PCN#20141119000

**Qualification of Alternate Assembly/Test Sites for Selected devices in the TSSOP
Package
Change Notification / Sample Request**

PCN Number:	20141119000			PCN Date:	12/03/2014
Title:	Qualification of ASE Shanghai as an alternate Assembly/Test Site for Selected devices in the TSSOP Package				
Customer Contact:	PCN Manager	Phone:	+1(214)480-6037		Dept:
Proposed 1st Ship Date:	03/03/2015		Estimated Sample Availability:	Provided upon Request	
Change Type:					
<input checked="" type="checkbox"/> Assembly Site	<input type="checkbox"/>	Assembly Process	<input checked="" type="checkbox"/>	Assembly Materials	
<input type="checkbox"/> Design	<input type="checkbox"/>	Electrical Specification	<input type="checkbox"/>	Mechanical Specification	
<input checked="" type="checkbox"/> Test Site	<input type="checkbox"/>	Packing/Shipping/Labeling	<input type="checkbox"/>	Test Process	
<input type="checkbox"/> Wafer Bump Site	<input type="checkbox"/>	Wafer Bump Material	<input type="checkbox"/>	Wafer Bump Process	
<input type="checkbox"/> Wafer Fab Site	<input type="checkbox"/>	Wafer Fab Materials	<input type="checkbox"/>	Wafer Fab Process

Sample product shipping label (not actual product label)

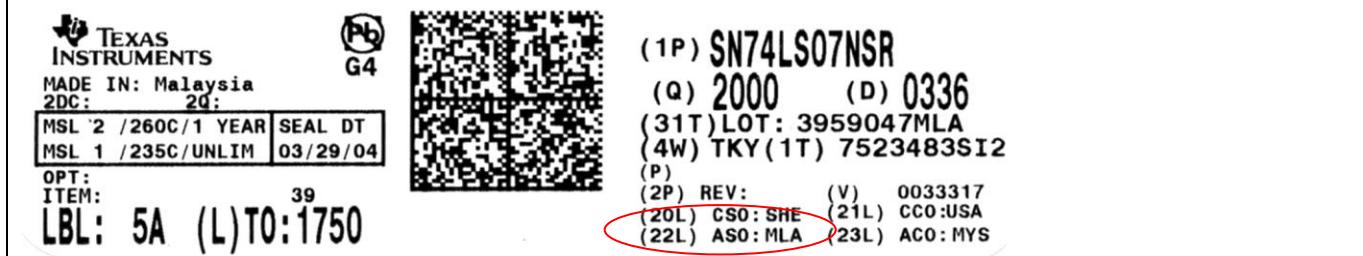
Changes to product identification resulting from this PCN:

Assembly Site	Assembly Site Origin (22L)	ASO: AKR
Amkor Philippines	Assembly Site Origin (22L)	ASO: MLA
TI Malaysia	Assembly Site Origin (22L)	ASO: TAI
TI Taiwan	Assembly Site Origin (22L)	ASO: ASH
ASE Shanghai	Assembly Site Origin (22L)
